Subject: CERTIFICATE OF COMPLIANCE NO. 9292 FOR THE MODEL NO. PATRIOT
PACKAGE: SUBMISSION of Response to Request for Additional Information (RAI) –
DOCKET No. 71-9292; TAC No. L23900

Enclosure 1: RAI Questions and Westinghouse Responses

Application for Certificate of Compliance for the Patriot BWR Fuel Shipping Package

Figure 3: Refurbished inner container showing overlapping lid liner

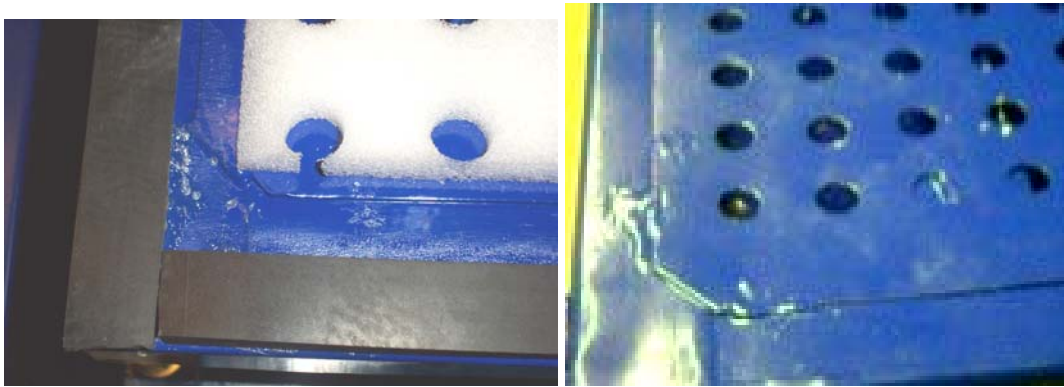
- 1-1 Provide revised package drawings that show all package configurations or modifications made during refurbishment activities. Show that these changes do not affect the ability of the package to meet the requirements of 10 CFR Part 71, particularly the requirements of 10 CFR 71.19(d)(2).

Recent QA inspection results show that during recent refurbishment activities, the licensee performed modifications to the package configuration that are not reflected in the package drawings. These package modifications included cutting and re-welding of the inner container lid ends. The applicant must ensure that the actual package configuration meets the description of the configuration provided in the drawings referenced in the Certificate of Compliance (CoC).

The second method, which was noticed during refurbishment, shows the lid liner overlapping the lid and being welded to it. Figure 3 shows two photographs of this configuration. Though not identified on the Patriot License Drawing, this is an acceptable configuration for an RA-3 type shipping package as it is shown on an earlier NRC-approved RA-3 License Drawing, as seen in Figure 4. Hence, this configuration does not affect the ability of the package to meet the requirements of 10CFR71. Section 8 of the SAR will be revised to include a sketch showing the overlapping method of attaching the lid liner to the lid.

Figure 5: Sketches of three end cap configurations (not to scale)

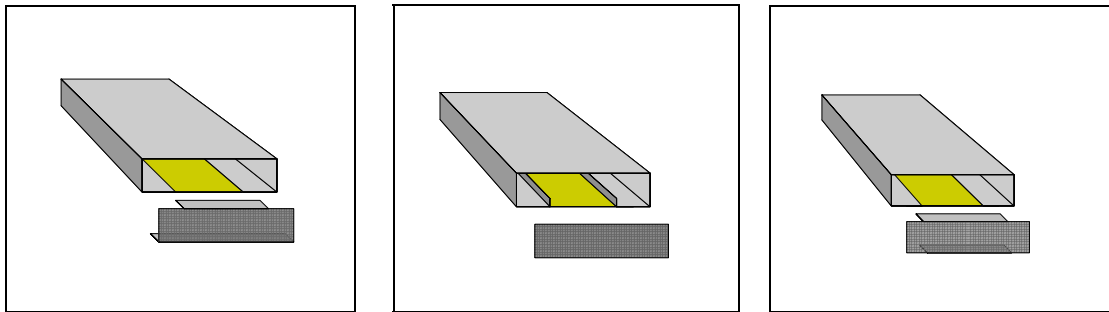
The recent NRC QA inspection team noted that the refurbishment activities included cutting and re-welding the inner container lid ends to the lids in a manner that was not reflected in the license drawings. The Patriot license drawings show an end cap design as depicted on the left in Figure 5. The detail from the Patriot license drawing is shown in Figure 6. This particular design has a full-length bottom tab and partial-length upper tab.

Two other lid end cap configurations are also shown in Figure 5. One is a flat plate and the other has partial-length top and bottom tabs. Though not identified on the Patriot License Drawing, they are acceptable configurations for RA-3 type shipping packages as both are shown on earlier NRC-approved RA-3 license drawings. Excerpted details of these are shown in Figure 7.

Hence, these configuration do not affect the ability of the package to meet the requirements of 10CFR71. Section 8 of the SAR will be revised to include a sketch showing these additional lid end cap configurations. The sketch is given in Figure 8.

Figure 9: Detail of inner base basket from Patriot license drawing 10014E28

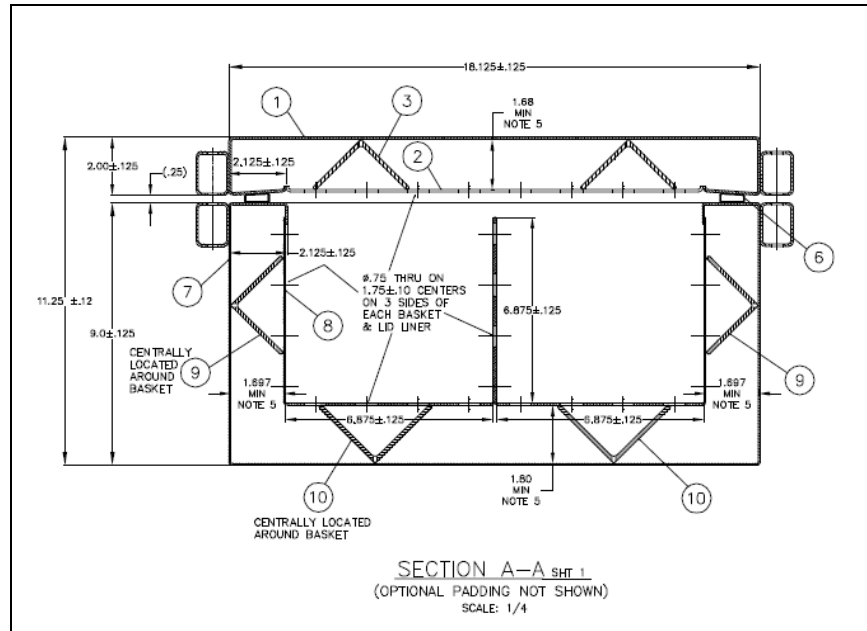
The Patriot license drawing provides very little information on the method for fastening the inner base basket. As can be seen in Figure 9, the drawing provides typical weld description.

Figure 10: Detail allowing optional basket fastening methods from RA-3 drawing 769E231

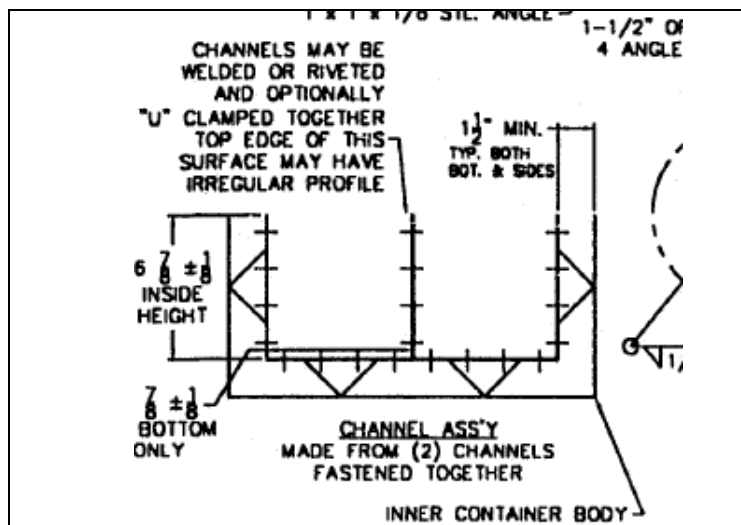
During the refurbishment it was found that some baskets (or channels) were fastened together with rivets or clamps. Note that Figure 10, a detail from an earlier NRC-approved RA-3 License Drawing, makes allowance for the channels to be otherwise fastened together. Hence, this configuration does not affect the ability of the package to meet the requirements of 10CFR71. Section 8 of the SAR will include a paragraph or a sketch that allows channels to be riveted or clamped together.

Figure 12: Detail A from Patriot license drawing 10014E28

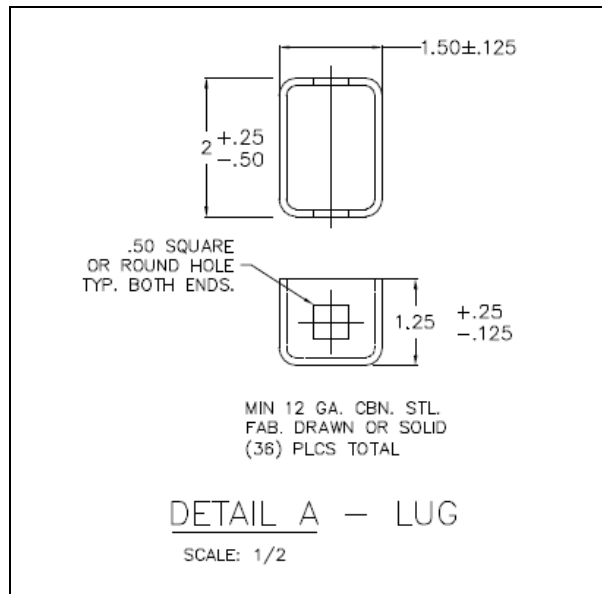
It was found that there were three bolting lug configurations on the Patriot inner container. They are shown in Figure 11. All are bounded by the license drawing Detail A, as shown in Figure 12.

Figure 14: Inner end cove assembly detail from Patriot license drawing 10014E28

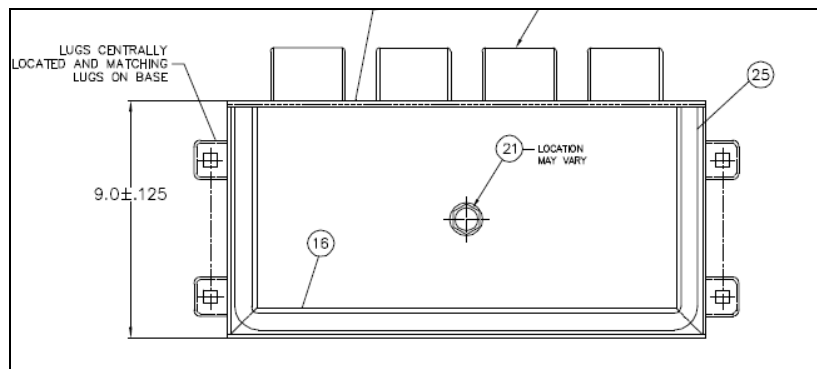
Finally, it was recognized during the refurbishment effort that the pressure vacuum relief valves were located in various spots. Figure 13 shows three locations. Again, the Patriot license drawing adequately bounds the found configurations, as can be seen in Figure 14.

Figure 8-1 Optional inner container lid end cap configurations

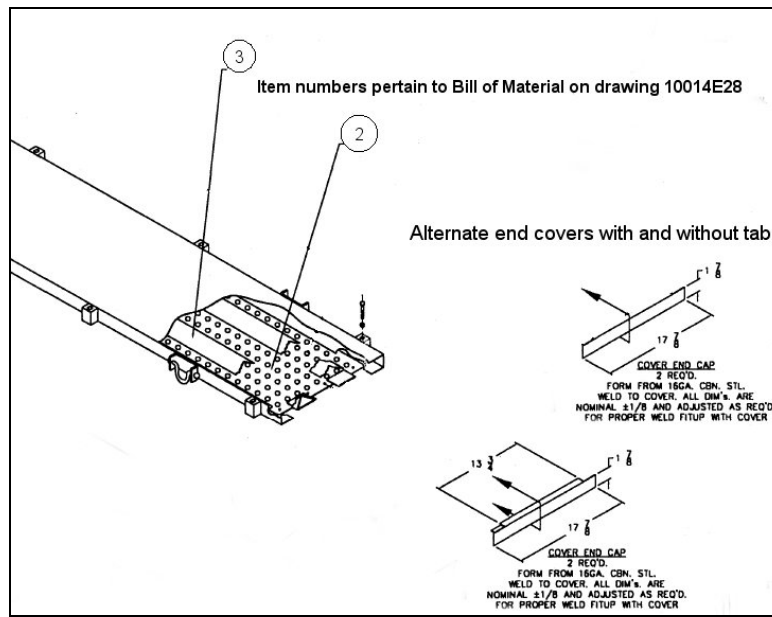
There are three acceptable end cap configurations. The first is shown in license drawing 10014E28. This configuration has a full-length bottom tab and partial-length upper tab. The other two configurations are shown in Figure 8-1, on the next page. One is a simple flat plate and the other has partial-length top and bottom tabs. During the cleaning and painting process described here, the end cap is re-attached as a simple flat plate.

Figure 8-6 Refurbished inner container showing overlapping lid liner

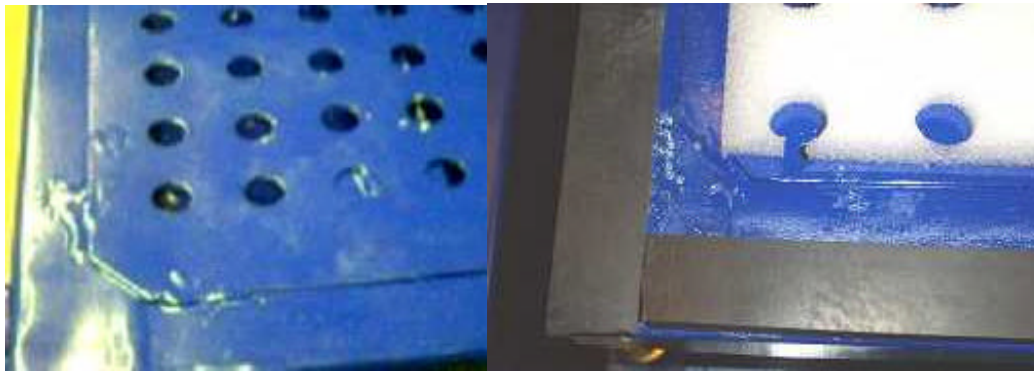
The second method has the perforated lid liner overlapping the lid and welded to it as shown in Figure 8-6, which shows two photographs of this configuration. Figure 8-7 is a sketch of this configuration.

Figure 8-8 Detail of inner base basket from Patriot license drawing 10014E28

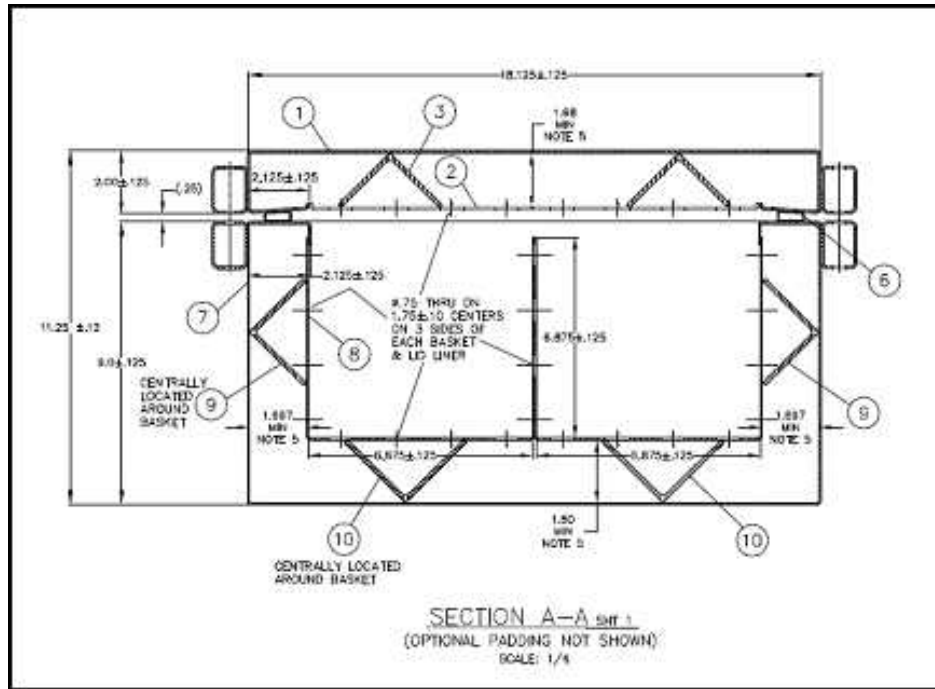
Baskets (or channels) may be fastened together with welds, rivets, or clamps as depicted in Figure 8-8 and Figure 8-9.
